Geotechnical Site Visit Report

Project Name: I-90 Hyak to West Snowshed Phase 1B	
Contract No: C7852	Page 1 of 2
Day: Tuesday	Date: October 18, 2011

Figure 2. A photograph of the exposed rock cut from approximately LW 1330+50 to 1332+25.

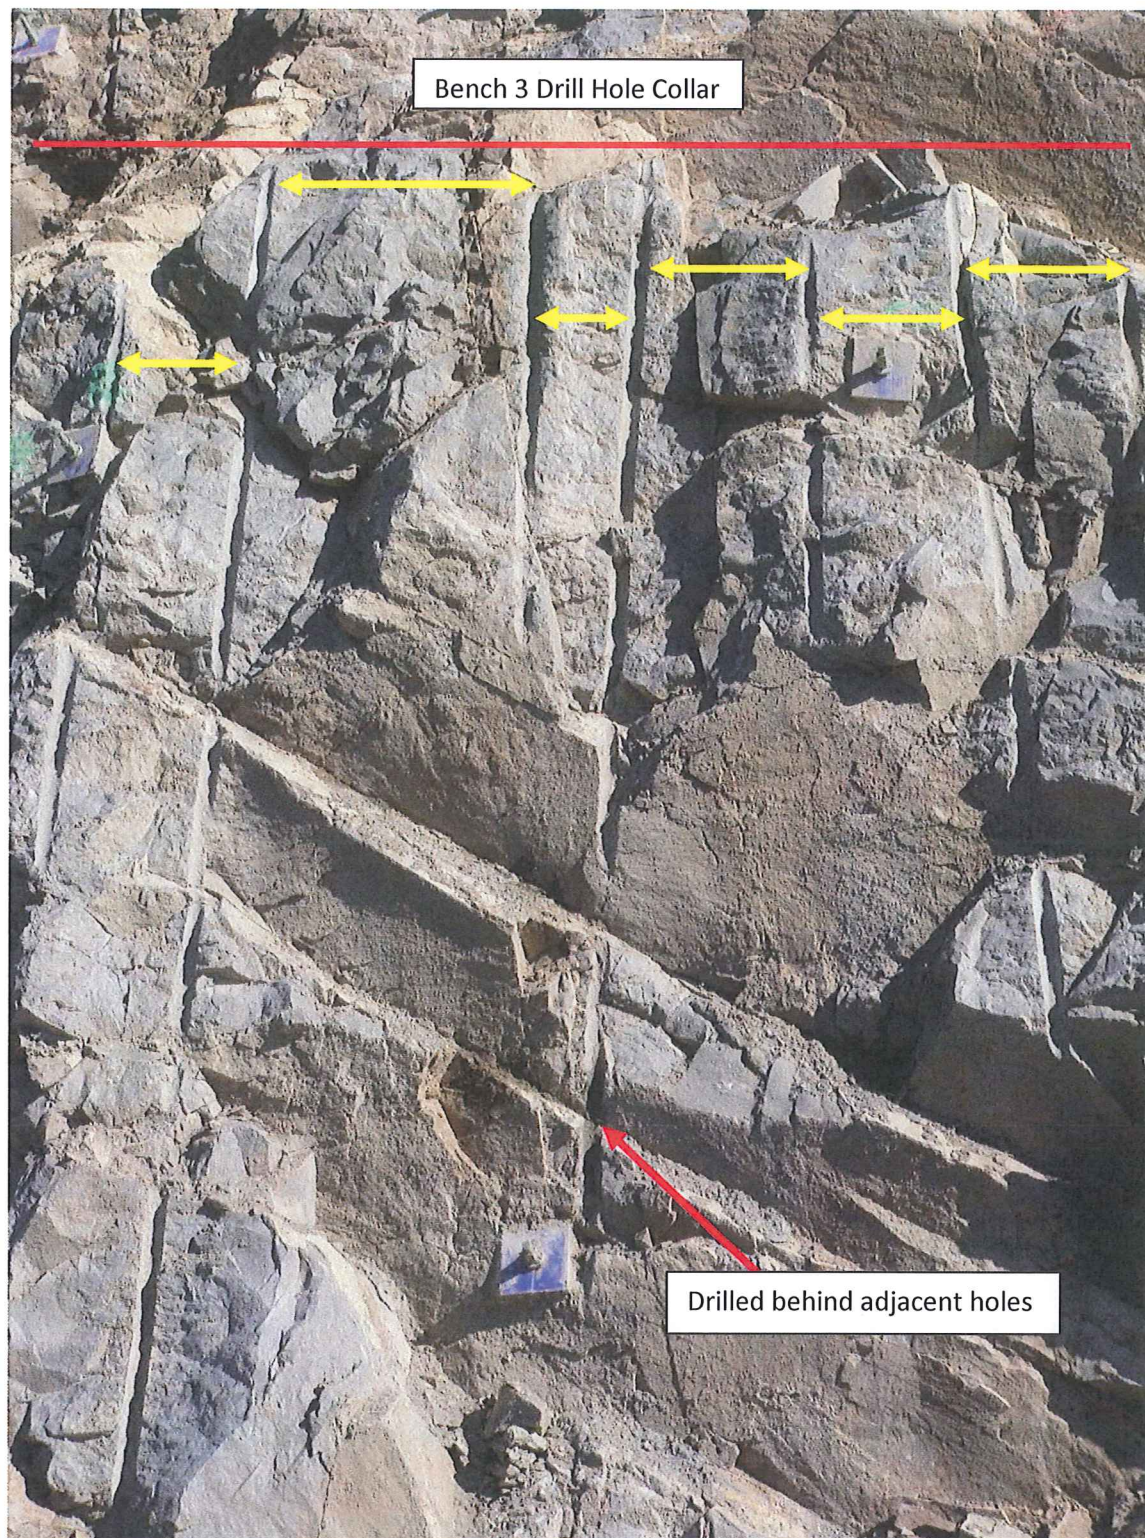
Jerry and my evaluation centered on the section that was accessible from approximately LW Station 1331+25 to 1332+25, where there is less geologic structure that may affect drilling operations. We thought this would be a representative section to evaluate the potentially improved performance of the preshear drilling efforts by Western States on Bench 3 and the upper six feet of Bench 2. As can be seen in Figure 3 and 4, the preshear line drill control issue continues to be a major problem. According to Brad Schut and Erik Warren, there have been considerable deductions for preshear lines for not meeting our deviation specification outlined in Section 2-03.3(2) under Controlled Blasting subsection (d). He estimated that between 25 and 30 percent of the holes are out of deviation when they are finally exposed, several weeks after drilling and blasting. In our opinion, Figure 3 illustrates the uneven spacing of the preshear drill holes at the collar elevation, indicating a total lack of effort, or care, to drill preshear lines at the spacing identified in their blast plan or within deviation specification. Figure 3 clearly indicates to us that the geology and drill equipment are not the problem; taking the time to setup the slope angle and properly space the drill holes is the problem. This blast hole alignment problem is not just a visual issue. The poor drill control of the preshear lines is concentrating explosives in the slope in some places and is limiting explosives needed to make a good preshear line in others. This is why the slope has a corduroy appearance. The poor preshear drilling control is resulting
